PRODUCT BULLETIN # 16571

Issue Date: 19-Jan-2011

TITLE: Shipping Tube change for SOIC Narrow Body (SOIC NB) devices and QSOP at ON Semiconductor Carmona, Philippines

AFFECTED CHANGE CATEGORY(S): Shipping

Table1. Details for new tube

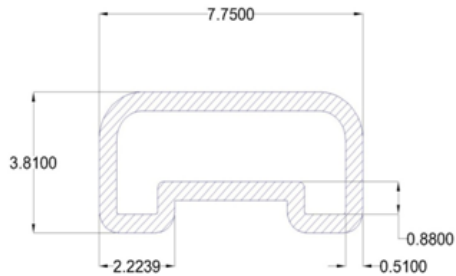
The new tubes are acquired from YOSIKO Industries Inc., Bulacan, Philippines. Further details are shown on the next page.

Figure1. Details of change

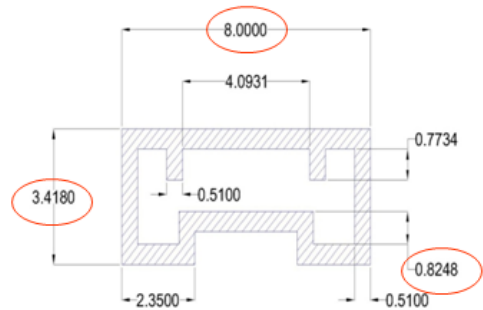
ON Semiconductor Carmona is changing the shipping tube used for SOIC NB (and QSOP) packages. This includes dimension change within the JEDEC specification and supplier change. The change is considered as Quality Improvement and Packaging robustness.

Length = 20.000 ± 0.050 inch
 Supplier: ITW Ampang, Laguna, Philippines

Length = 20.6751 ± 0.050 inch
 Supplier: YOSIKO, Bulacan, Philippines
